## **Planning Commission Work Session Agenda**

| Project Number    | WVR 54672 & LSD 54538                                                      |
| Nature of Request | Seeking a waiver of Sec. 107-250(m) for a proposed large-scale development |

# COOPER CHAPEL OPERATIONS BUILDING LARGE SCALE DEVELOPMENT

## SITE PLAN

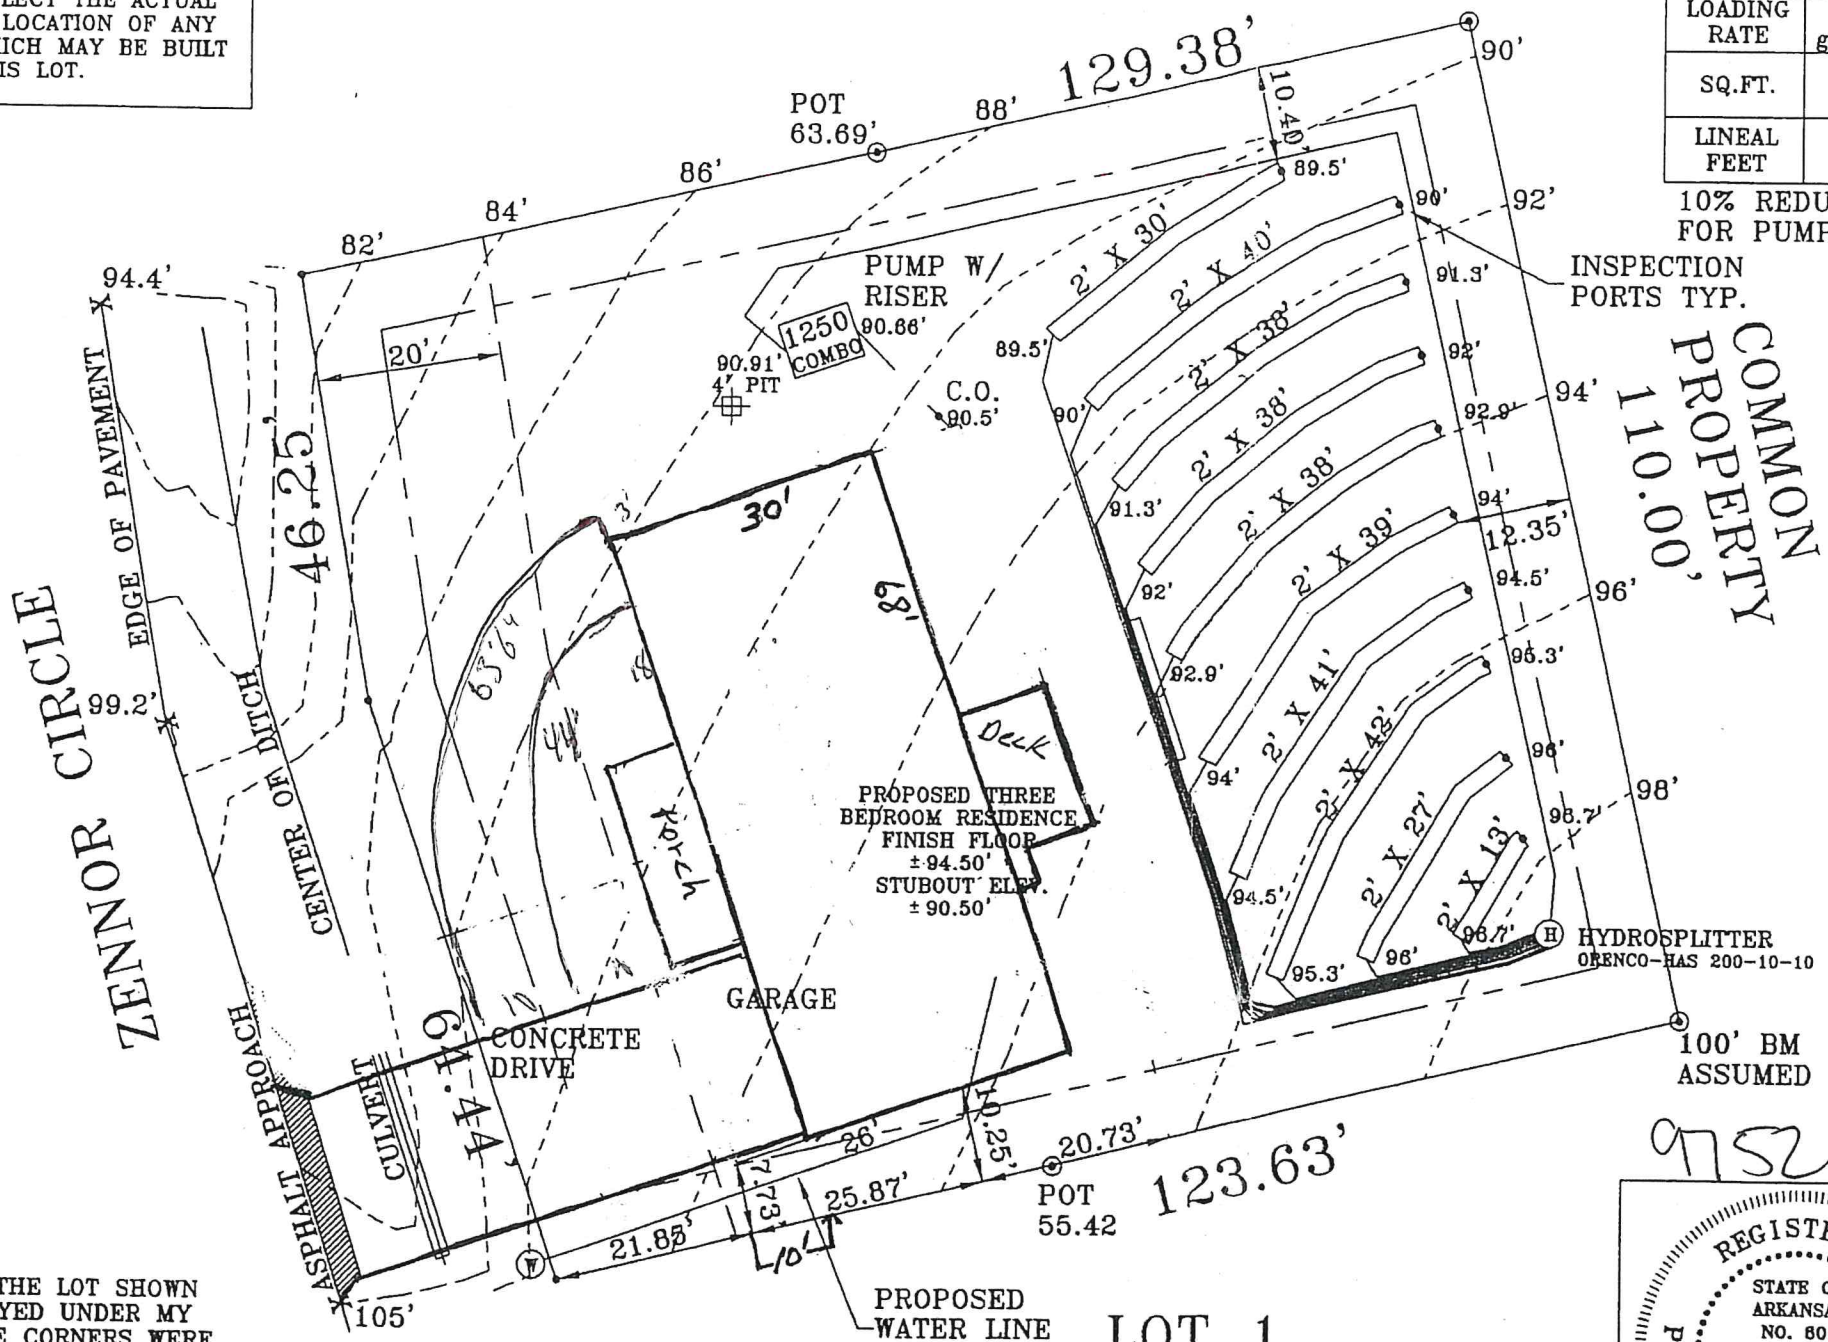
- The retaining wall doesn't appear to affect the electric service line from the pole at the NW corner of the lot to the meter on the house.
- As long as no fill is added over the electric service line that would require the line to be rerouted, then Carroll Electric has no concerns with this proposal.

Sec. 107-341(b) Provide construction details that include the following:  
(1)Dimensions and height of the wall;  
(2)Cross section of the wall including footing design;  
(3)Elevations above and below the wall; and  
(4)Proposed wall material.
